KINGSWAY & BROADWAY REZONING APPLICATION

12 April 2011 – City of Vancouver Community Open House

Prepared by: Rize Alliance and Acton Ostry Architects

UPDATE

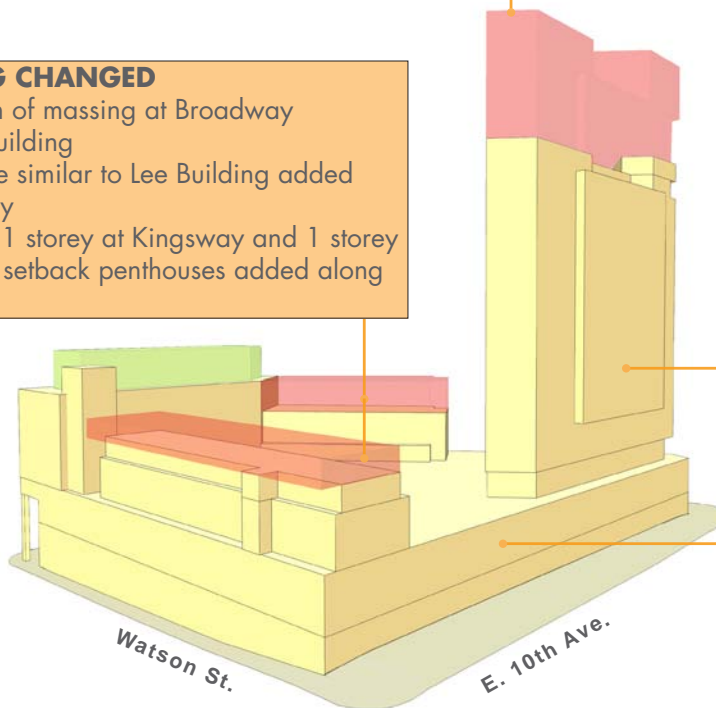
OVERALL HEIGHT REDUCED BY 27%

- before: 26 storeys – now: 19 storeys

LOW MASSING CHANGED

- height and form of massing at Broadway similar to Lee Building
- masonry arcade similar to Lee Building added along Broadway
- height reduced 1 storey at Kingsway and 1 storey at Watson with setback penthouses added along Broadway

OVERALL DENSITY REDUCED BY 17%

- before: 6.44 FSR – now: 5.33 FSR
